UNITED STATES  
NUCLEAR REGULATORY COMMISSION  
WASHINGTON, D.C. 20555-0001

SUBJECT: COOPER NUCLEAR STATION - STAFF ASSESSMENT OF INFORMATION PROVIDED PURSUANT TO TITLE 10 OF THE *CODE OF FEDERAL REGULATIONS* PART 50, SECTION 50.54(f), SEISMIC HAZARD REEVALUATIONS FOR RECOMMENDATION 2.1 OF THE NEAR-TERM TASK FORCE REVIEW OF INSIGHTS FROM THE FUKUSHIMA DAI-ICHI ACCIDENT (TAC NO. MF3734)

STAFF ASSESSMENT BY THE OFFICE OF NUCLEAR REACTOR REGULATION

COOPER NUCLEAR STATION

Figure 3.3-1 Plot of Staff's and Licensee's Base Case Shear-Wave Velocity Profiles for the Cooper Nuclear Station site

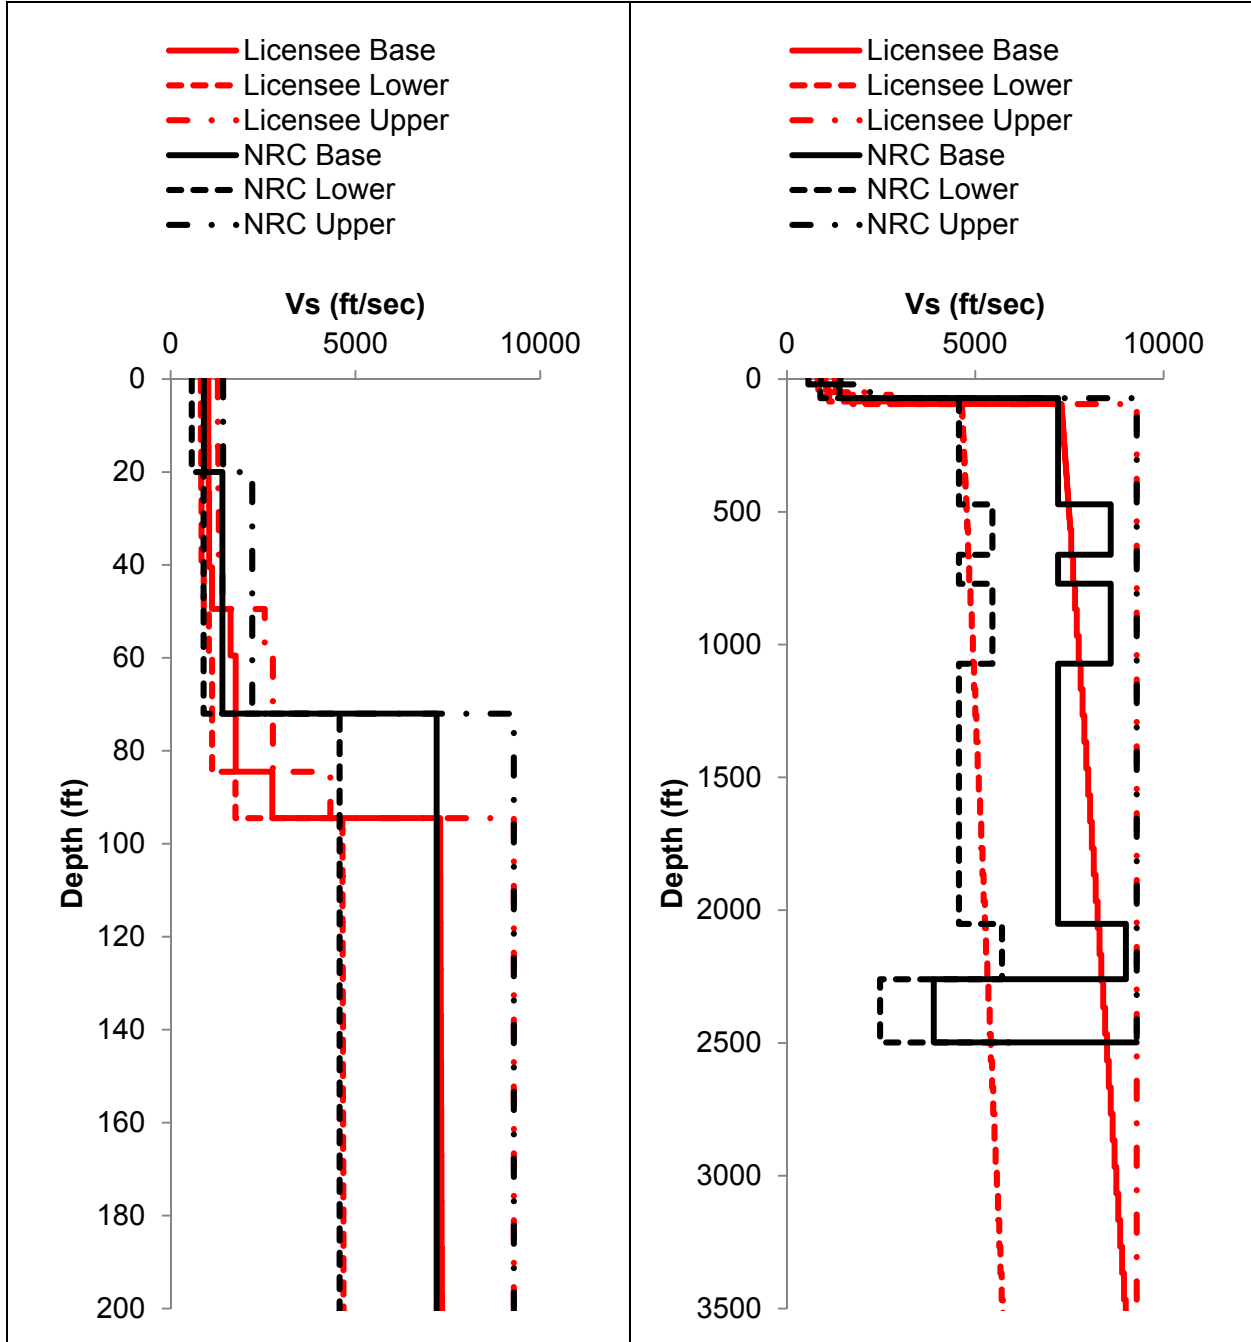
To characterize the subsurface geology, the licensee developed three site base case profiles. For the middle, or best estimate, profile, the licensee estimated a value of 7,292 ft/s [2,223 m/s] for the firm rock layers below a depth of 128 ft [39 m] based on the lithology of the rock. To develop the upper and lower base case profiles, the licensee used a scale factor of 1.25 for the upper 49.5 ft (15 m) and 1.57 below to reflect increased uncertainty for assumed shear wave velocities. Figure 3.3-1 of this assessment shows the licensee's three shear-wave velocity base case profiles.

To characterize the uncertainty in the subsurface material properties, the NRC staff developed three separate profiles. The NRC staff's shear wave velocity profiles are very similar to those submitted by the licensee in the upper 80 ft, but differ somewhat below 80 ft. The differences are due to the NRC staff's use of the shear wave velocities for similar rock units at other nuclear sites in the region while the licensee used a generic velocity profile from the SPID. The NRC staff's base case shear-wave velocity profiles along with the licensee's base case profiles are shown in Figure 3.3-1 of this assessment.

Figure 3.3-2 Plot Comparing the Staff's and the License's Median Amplification Functions and Uncertainties for two input loading levels for the Cooper Nuclear Station site

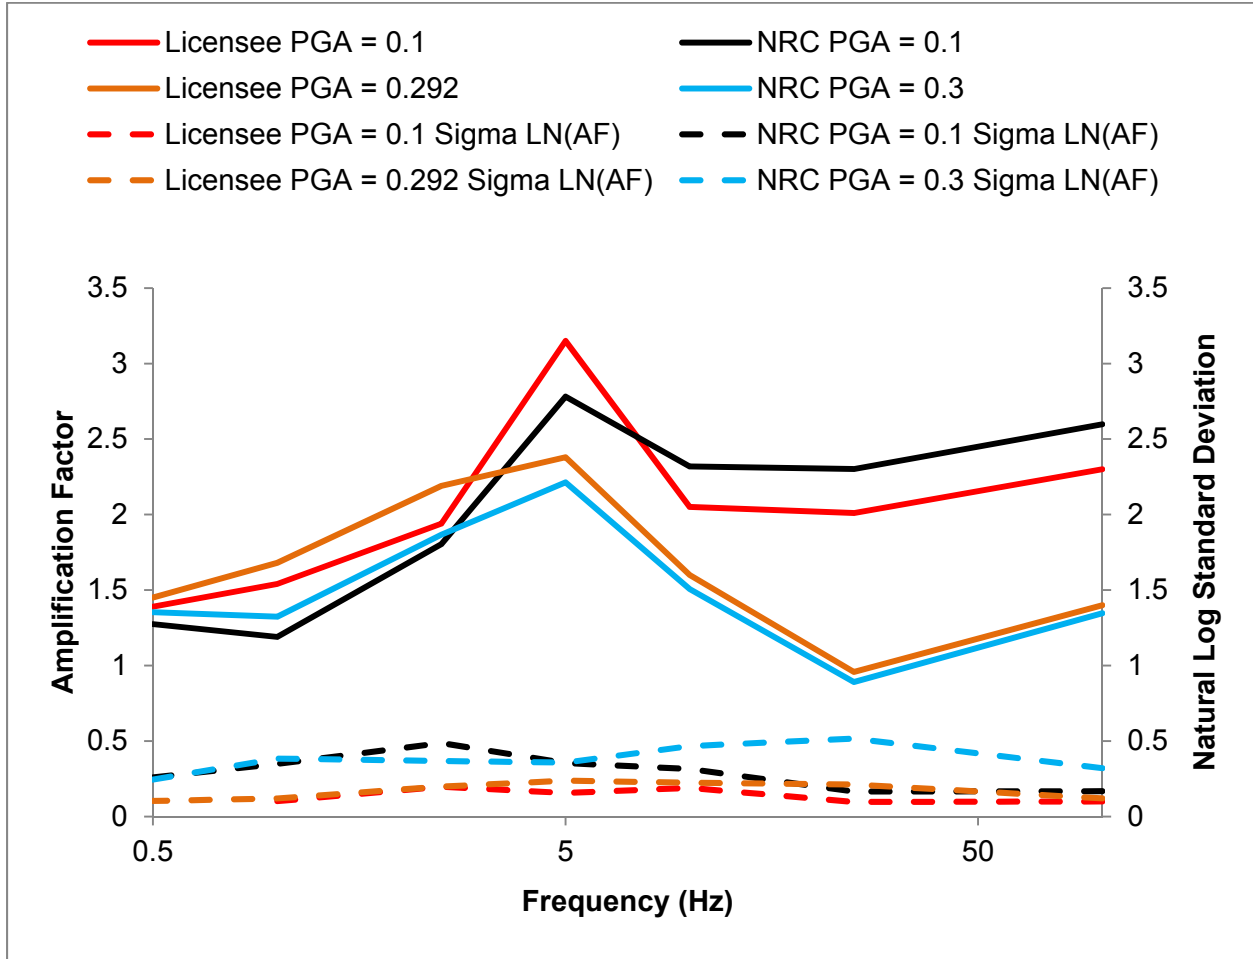
Figure 3.3-2 of this assessment shows a comparison of the NRC staff's and licensee's median site amplification functions and uncertainties for two of the eleven input loading levels for profiles used in the licensee's SHSR submittal. As shown in Figure 3.3-2, the differences between the NRC staff's and licensee's amplification functions and uncertainties are very minor. Figure 3.3-3 of this assessment compares the control point hazard curves at 1 Hz, 10 Hz, and PGA developed by the NRC staff with those developed by the licensee in its SHSR. Again the licensee's and NRC staff's control point hazard curves are very similar. These small differences in the site response analysis do not have a large impact on the control point seismic hazard curves or the resulting GMRS, as discussed below.

Figure 3.3-3 Plot Comparing the Staff's and the Licensee's Mean Control Point Hazard Curves at a Variety of Frequencies for the Cooper Nuclear Station site

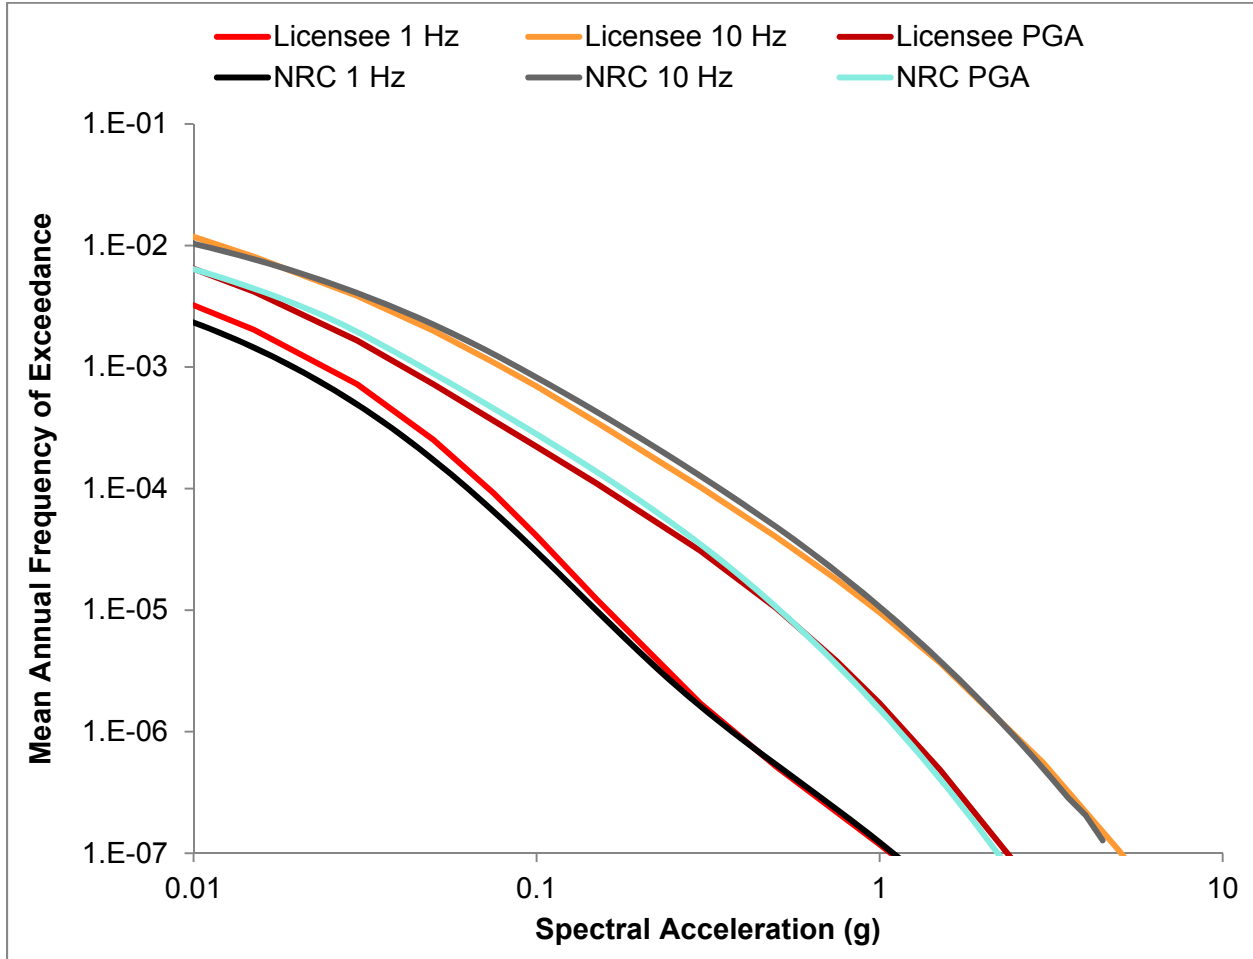
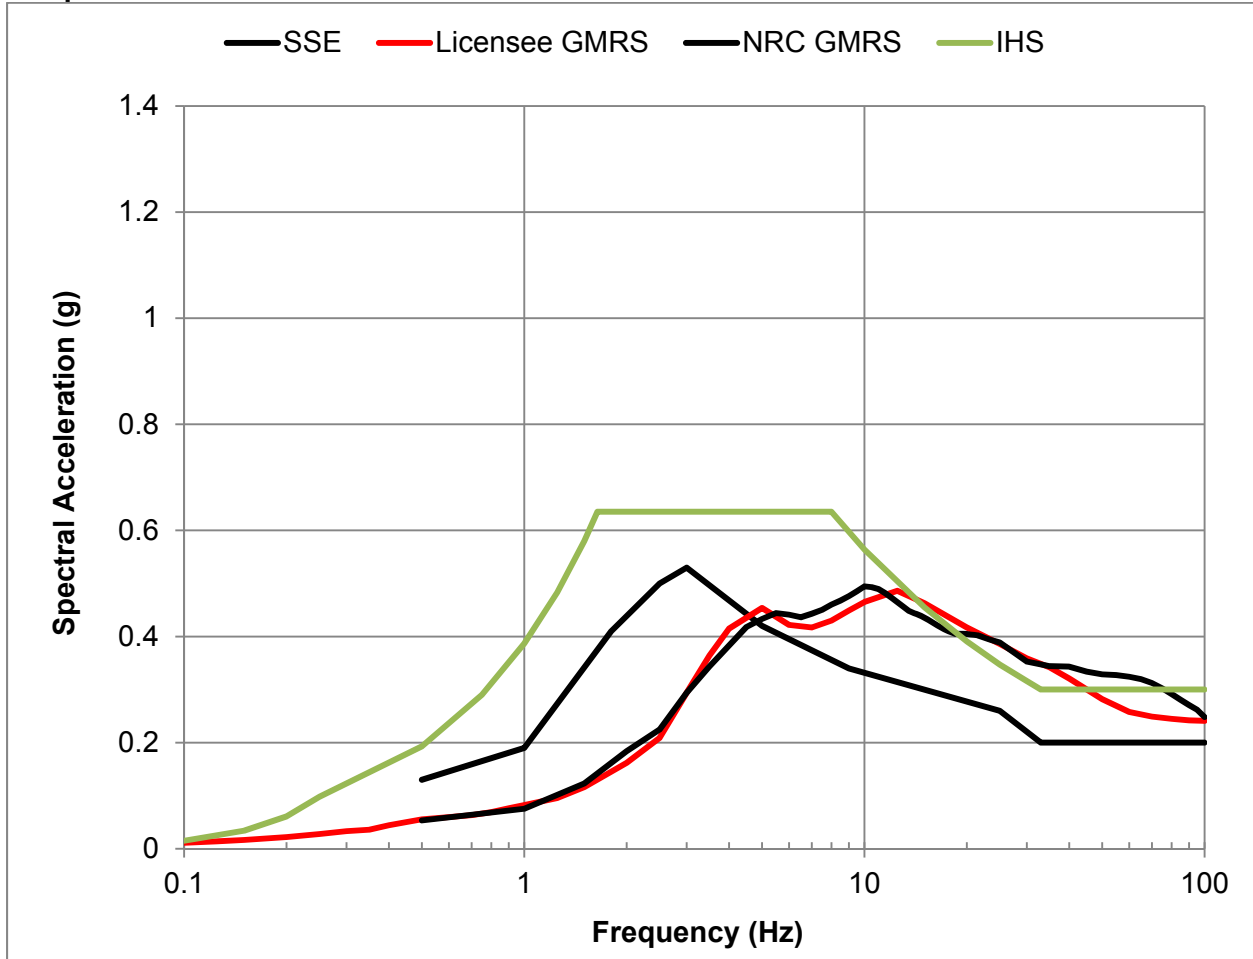
The NRC staff independently calculated the  $10^{-4}$  and  $10^{-5}$  UHRS using the results of its confirmatory PSHA and site response analyses, as described in Sections 3.2 and 3.3 of this staff assessment, respectively. Figure 3.4-1 of this assessment shows a comparison of the GMRS determined by the licensee to that determined by the NRC staff. As shown in Figure 3.4-1, the licensee's GMRS is very similar to that determined by the NRC staff.
